Access Compliance Report Public Rights-of-Way (Curb Ramps)

Main Street: BENJAMIN_DR Cross Street: ARTISAN_ST Location: W

ADA ID: RPRK211020160634 Ramp Type: Type 1 - Perpendicular Diagonal Initial Pass/Fail: Pass Overall Compliance: No Severity Score: 20

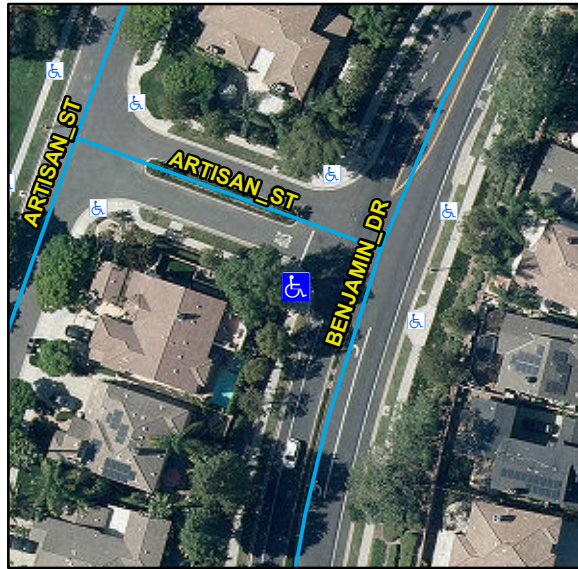
Compliance	Description	Data	Compliance	Description	Data
N/A	Ramp Length (in)	125	N/A	Flare Type LT	
Yes	Ramp Width (in)	48			Sloped
Yes	Ramp Run Slope (%)	7.6	N/A	Flare Slope LT (%)	3.2
Yes	Ramp Cross Slope (%)	1.4	N/A	Flare Traversable LT	No
N/A	Landing Present	Yes	N/A	Flare Type RT	
N/A	Landing Length (in)	38			Sloped
Yes	Landing Width (in)	48	N/A	Flare Slope RT (%)	6.7
No	Landing Run Slope (%)	3.8	N/A	Flare Traversable RT	No
No	Landing Cross Slope (%)	2.4	No	DWS Provided	No
N/A	Landing Movement Obstructed?	No	N/A	DWS Contrast	N/A
	Landing Movement Type	N/A	N/A	DWS Length (in)	N/A
N/A	Landing Shared	No	N/A	DWS Full Width	N/A
N/A	Clear Space	Yes	N/A	DWS Offset Left (in)	N/A
N/A	Clear Space To Crosswalk (in)	48	N/A	DWS Offset Right (in)	N/A
N/A	Marked Crosswalk 1	No	N/A	Marked Crosswalk 2	No
	Crossing 1 Direction	SE		Crossing 2 Direction	NE
	Marked Crosswalk 1 Width (in)	N/A		Marked Crosswalk 2 Width (in)	N/A

N/A	Ramp Inside Crosswalk 1	N/A	Yes	Ramp Inside Crosswalk 2	N/A
	Crossing 1 Slope (%)	3.8		Crossing 2 Slope (%)	5.2
	Crossing 1 Cross Slope (%)	2.1		Crossing 2 Cross Slope (%)	0
Yes	Gutter Ponding	No	No	Curb Slope	8.5
Yes	Gutter Lip Height (in)	0		Road Run Slope (%)	1
No	Gutter Run Slope (%)	8.2		Road Cross Slope (%)	3.3
Yes	Gutter Cross Slope (%)	0.6			
Yes	Overall Surface Condition: Acceptable		No	Perp Joint Present	No
	Cross Gutter Present?	No		Spandrel Present?	No
	Replace Cross Gutter?	N/A		Replace Spandrel?	N/A

Remove & Replace Curb Ramp With Two New Directional Ramps or Equivalent. Remove & Replace Gutter.
